SUBJECT: Transmittal of Revised Responses to AP1000 DSER Open Items

**AP1000 Design Certification Review
Draft Safety Evaluation Report Open Item Non-Proprietary Responses**

DSER Open Item Number: 3.6.3.4-2 Addendum 1 Revision 2

Figure 9 – Isometric View: Comparison of AP600 and AP1000 DVI-A Piping System

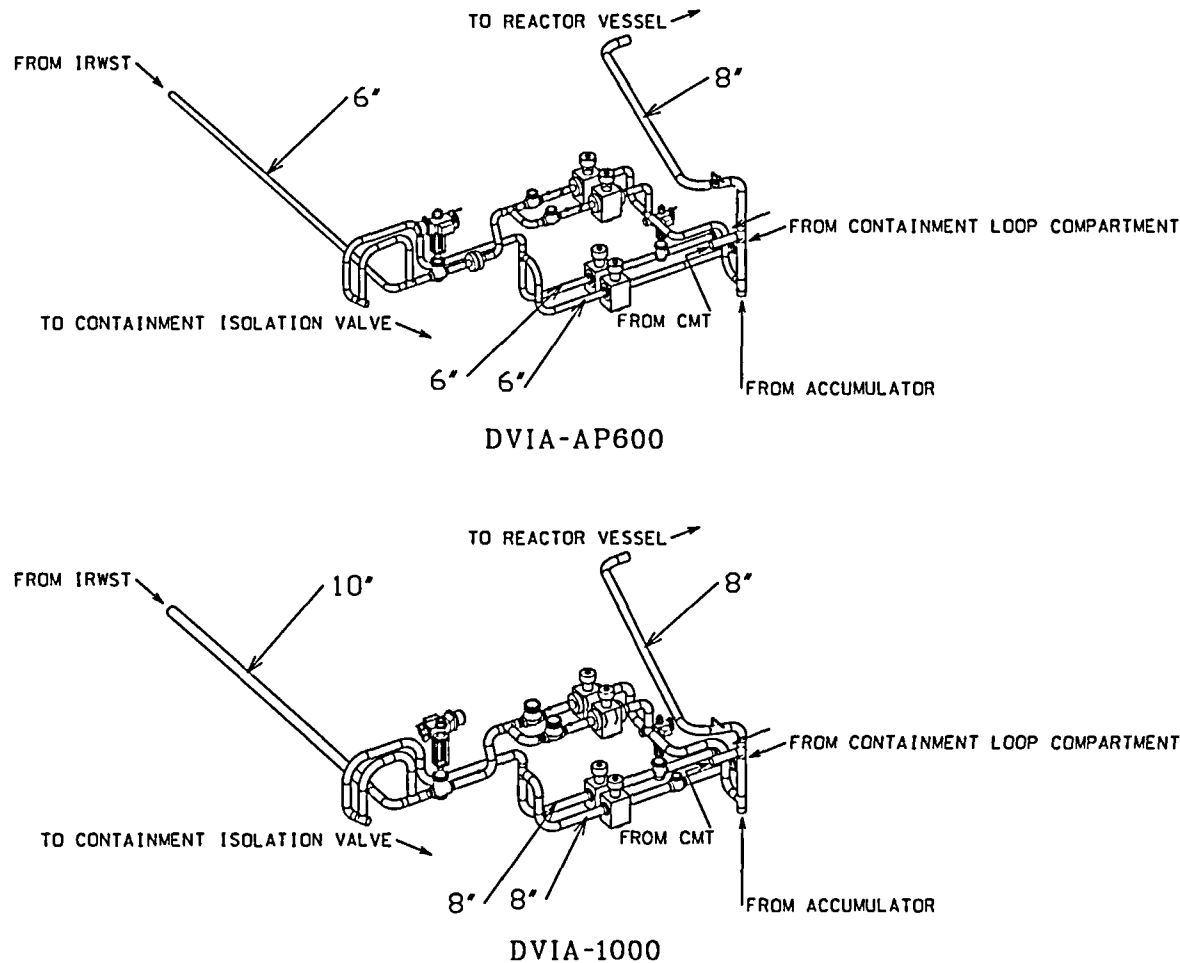
Complexity of piping system - The DVI-A piping system is complex, and was particularly challenging to qualify for the AP600. The AP600 design and analysis of the DVI-A subsystem was performed over several iterations that included perturbations in the piping layout, support configuration, and piping analysis. Figure 9 shows isometric views of both the AP600 and AP1000 DVI-A piping system.

Figure 10 - Bounding Analysis Curve – DVI-A – 8" (316 SS, 537 °F)

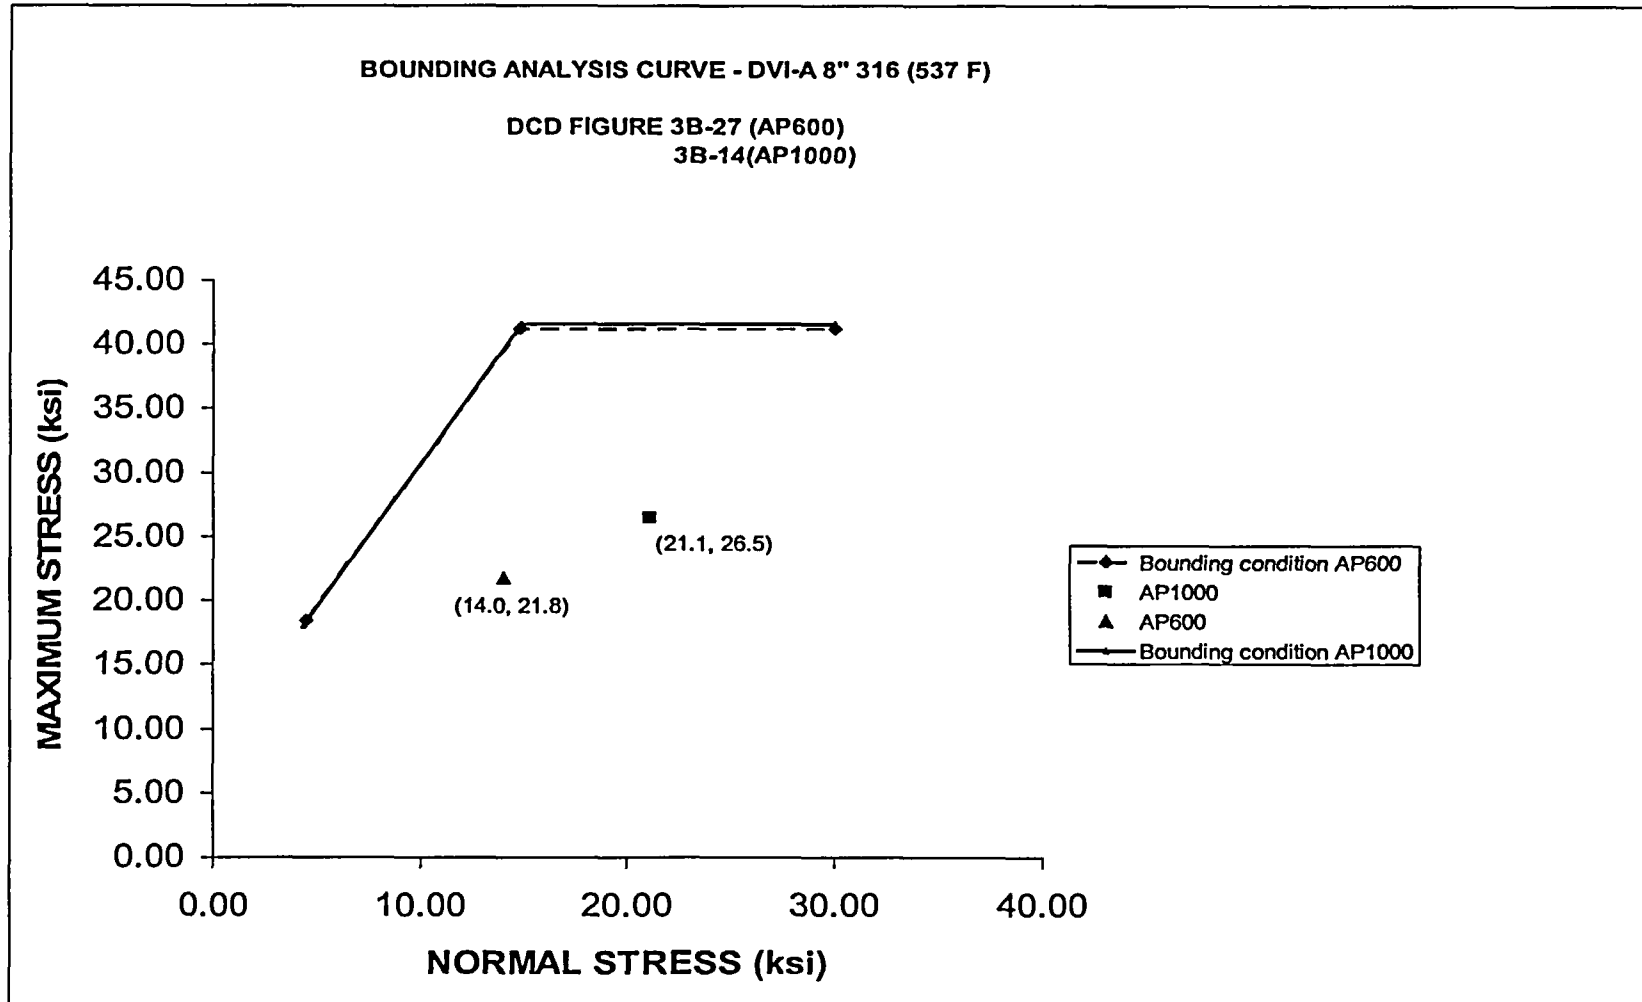
Revision 2 of this response provides discussion and results of revised DVI-A piping analysis in Section 2.5 and Figures 10-15 of this addendum.

Table 3 Summary of DVI-A Preliminary Piping Stress Analysis Results			
Pipe Segment	Maximum Calculated Stress (ksi)	Bounding Analysis Curve Limit (ksi)	Report Figure
8-inch, 316SS, 537F	26.523.9	41.6	Fig. 10
8-inch, 316SS, 120F	25.822.0	51.944.0	Fig. 11
8-inch, 304	14.813.8	16.214.4	Fig. 12
8-inch, Sch 40S	14.611.7	22.7	Fig. 13
6-inch, RNS	14.614.5	26.122.9	Fig. 14
8-inch, PXS	26.522.3	45.444.5	Fig. 15

Figure 16 - Bounding Analysis Curve – Primary Loop Hot Leg – 31”

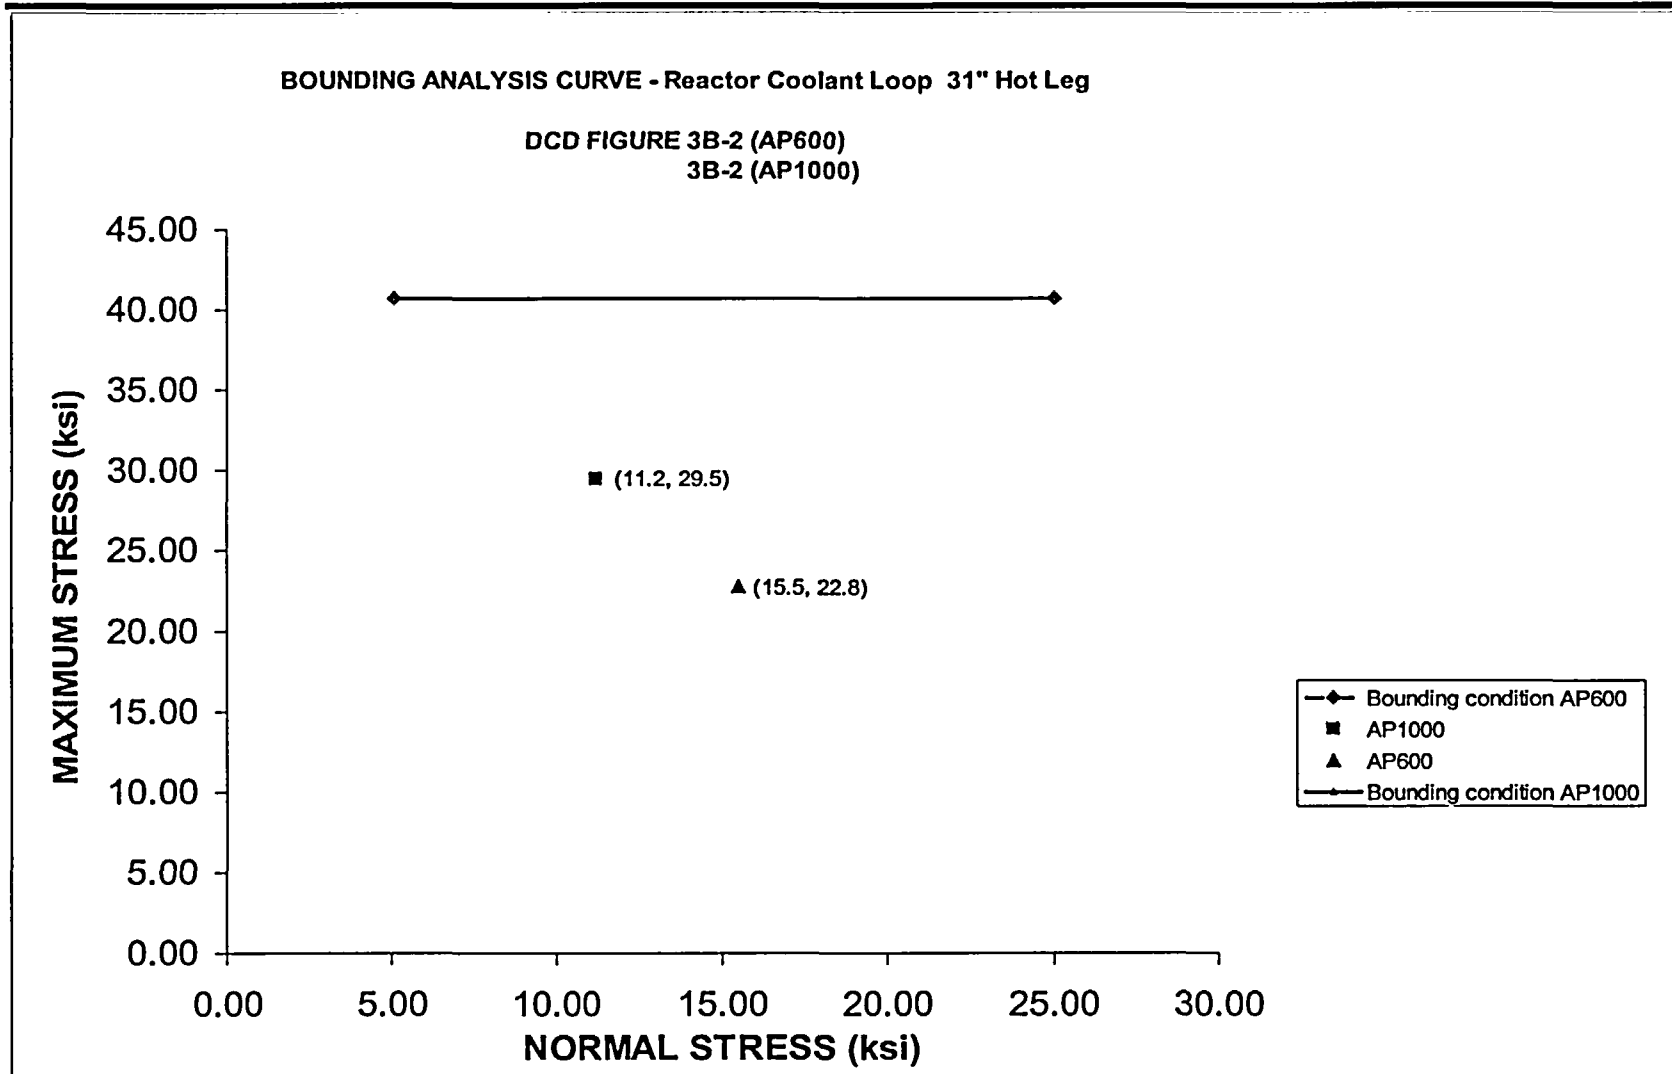
The Hot Leg pipe diameter is the same as AP600. The seismic multiplication factor is 1.74. This includes the affect of the higher elevation of the steam generator upper lateral support. The maximum stress is 29.5 ksi which is less than the BAC stress of 40.7 ksi. Figure 16 shows the BAC and the estimated stresses for the AP1000 plant. Feasibility of LBB for AP1000 is confirmed.

Figure 17 - Bounding Analysis Curve – Primary Loop Cold Leg – 22"

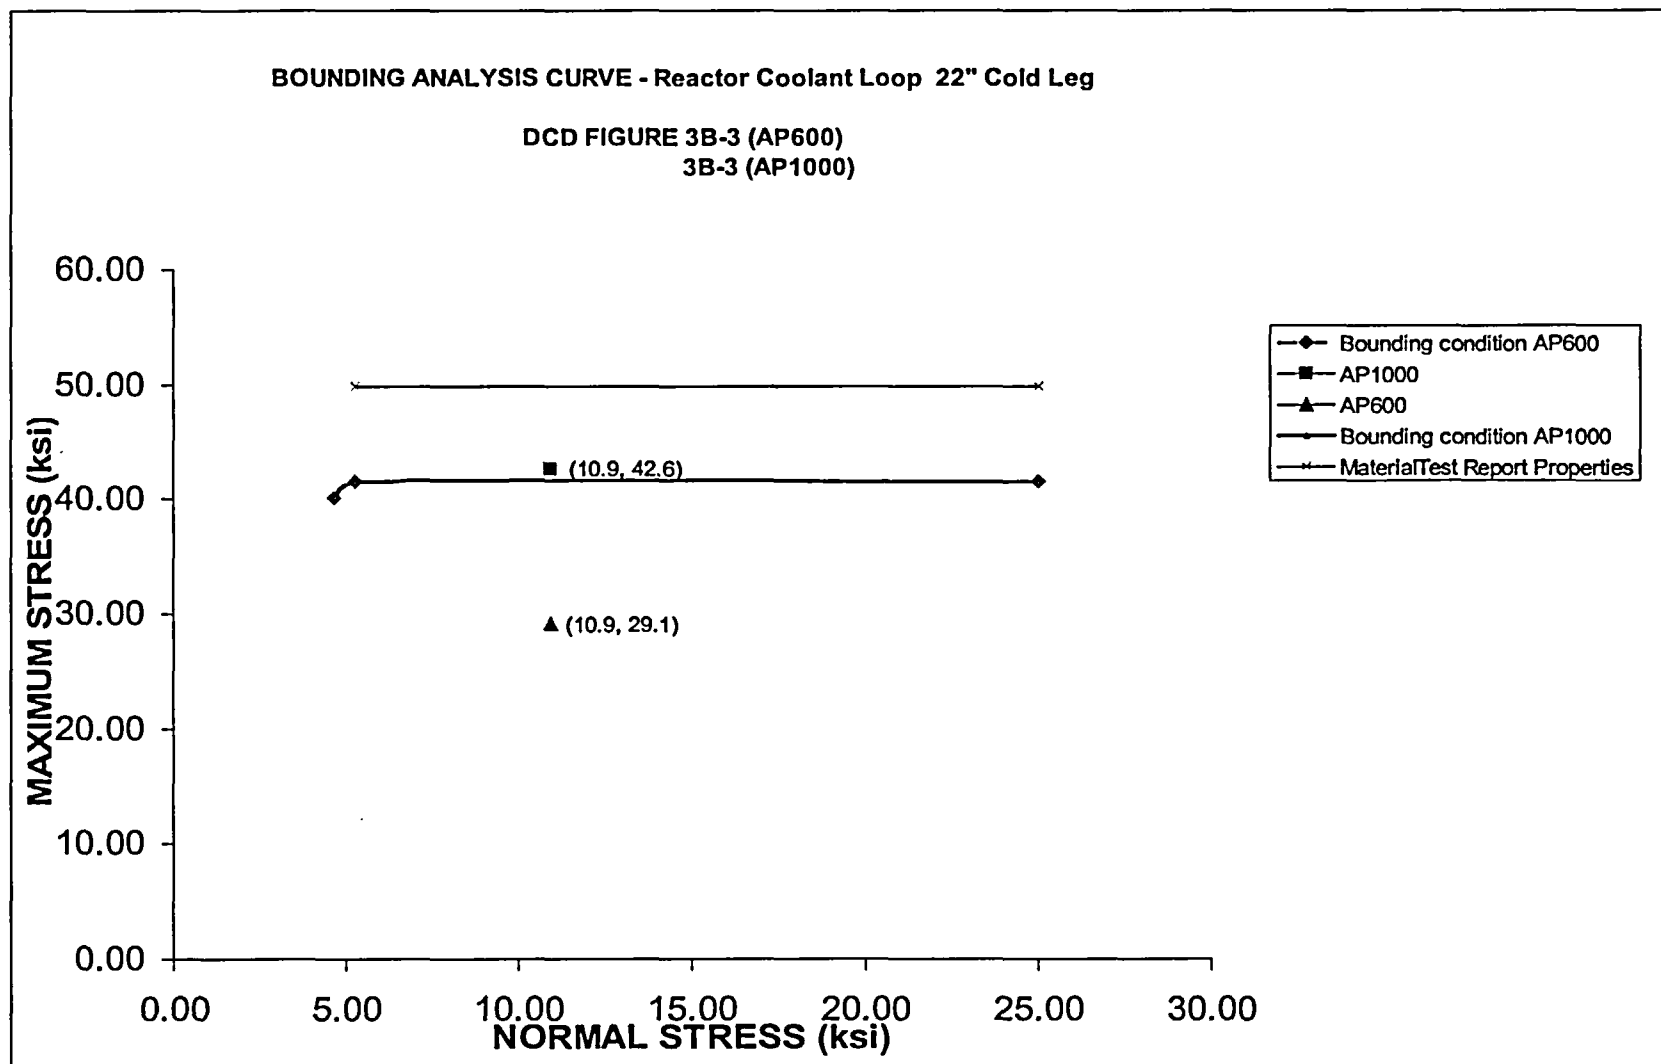
The Cold Leg pipe diameter is the same as AP600. The seismic multiplication factor is 1.74. This includes the affect of the higher elevation of the steam generator upper lateral support. The maximum stress is 42.6 ksi which is lower than the modified BAC stress of 49.9 ksi. Figure 17 shows the BAC and the estimated stresses for the AP1000 plant. Therefore, the feasibility of LBB for AP1000 is confirmed.

Figure 22 - Pressurizer Safety Valve Inlet Pipe Break Protection (Sheet 1 of 2)

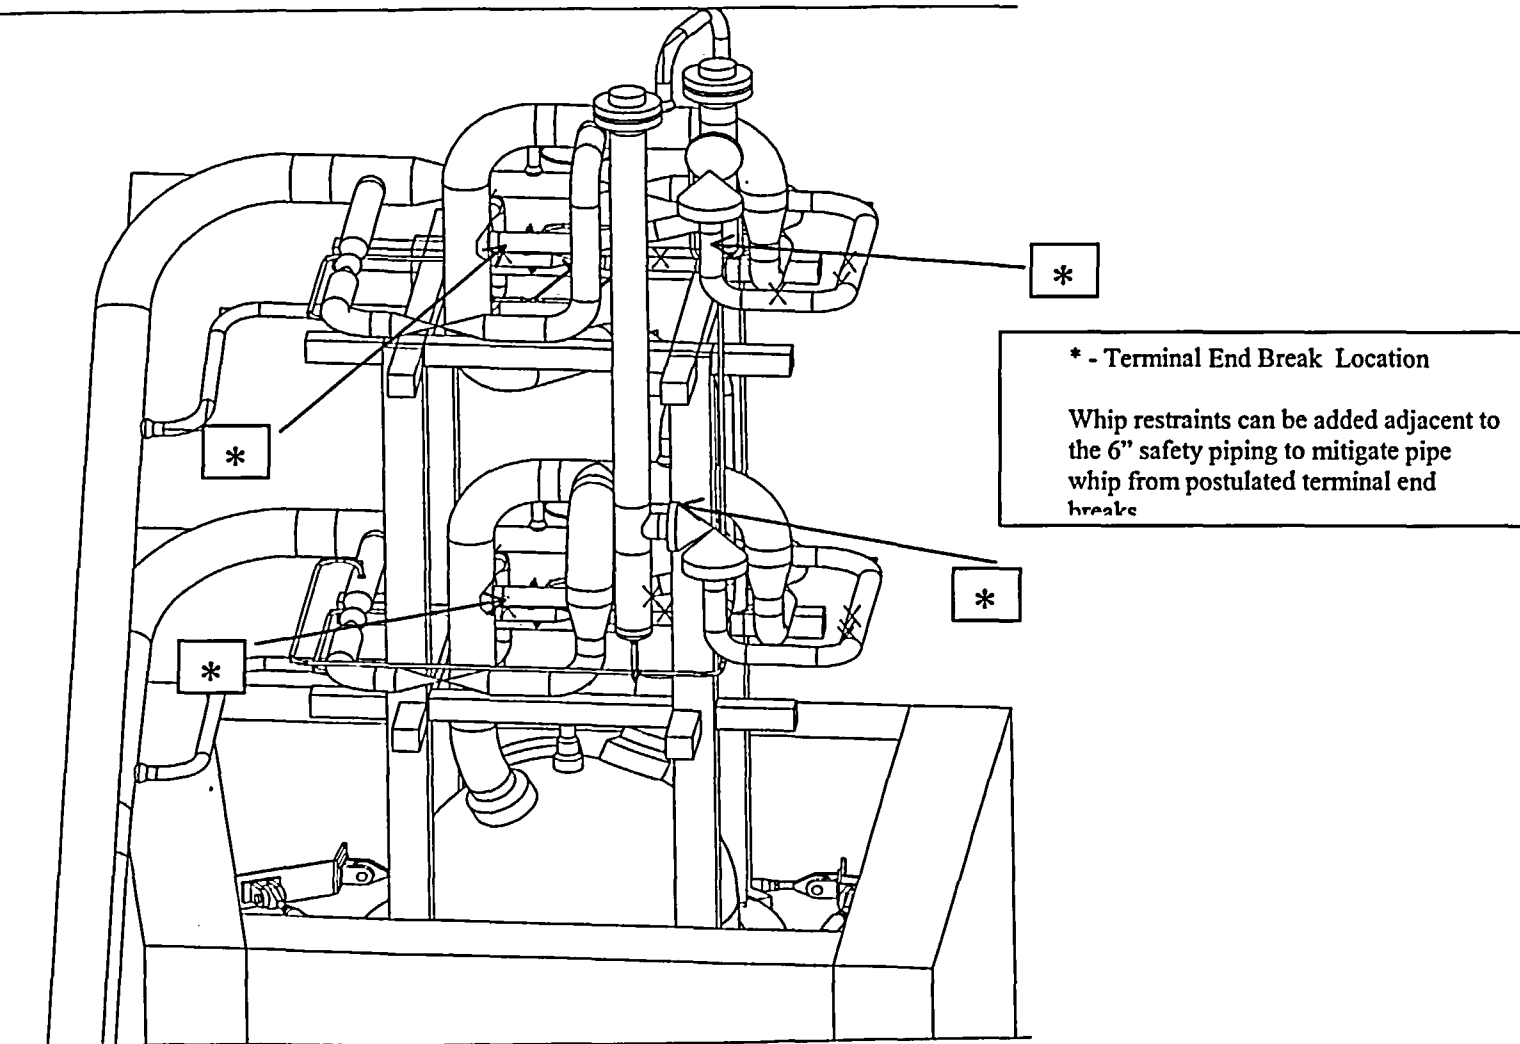
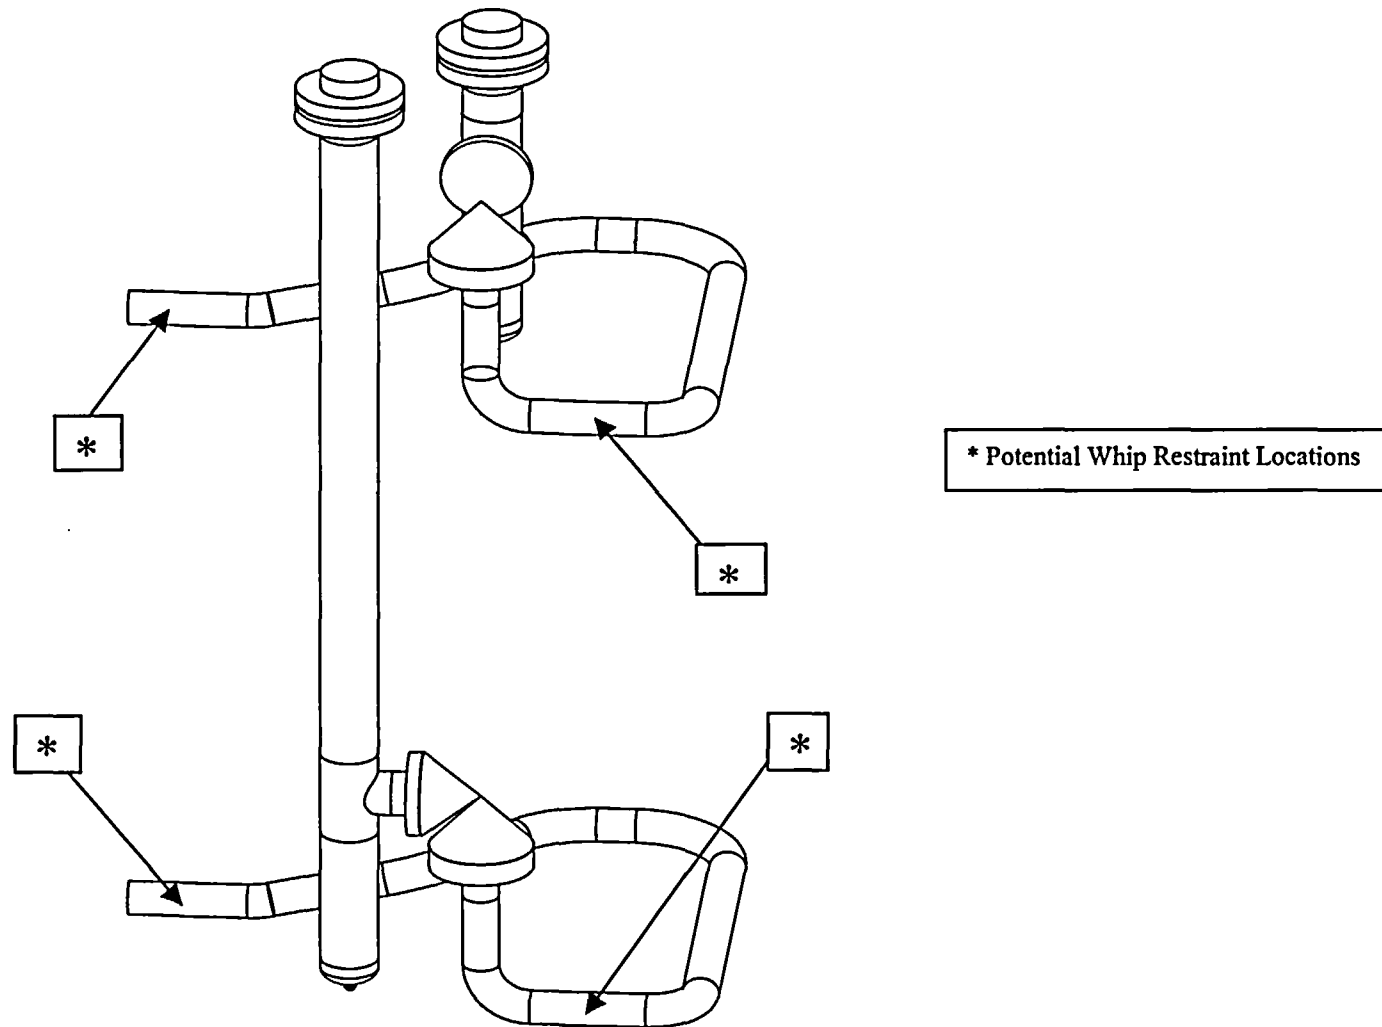
The Pressurizer Safety pipe diameter is the same as AP600. The seismic multiplication factor is 2.71. This includes the affect of the higher elevation of the pressurizer upper lateral support. The maximum stress is 61.9 ksi which is higher than the BAC stress of 40.4 ksi. Figure 21 shows the BAC and the estimated stresses for the AP1000 plant. This stress is calculated based on the conservative methods previously described in Section 2. Utilizing detailed time-history seismic analysis methods as opposed to response spectra methods previously utilized for AP600, it is anticipated that the analytical results will be significantly lower than those obtained by the conservative ratios developed. In the event that the results from the detailed time-history seismic results still exceed the BAC limits, the affects of postulated high energy line pipe breaks in the two 6" Safety lines would need to be evaluated. These pipe breaks are above the top of the Pressurizer subcompartment walls, and do not effect the design for subcompartment pressurization. Therefore the breaks would not have any adverse impact on the structural design of the Containment Internal Structure. Pipe whip restraints can be installed on the ADS pressurizer platforms at the locations shown in Figure 22 to ensure that the adjacent components that are needed to mitigate the pipe break (i.e. ADS Stage 1, 2, and 3 valves and piping)are not compromised.

This report summarizes an assessment of applying Leak-Before-Break methodology to the candidate AP1000 plant pipe lines listed in Table 1. Feasibility is demonstrated for the LBB candidate piping systems with one possible exception of the Pressurizer Safety Valve inlet piping (6"). For these two lines, the high energy pipe breaks can be mitigated by the installation of protection devices (whip restraints) as shown at the locations in Figure 22 if required.
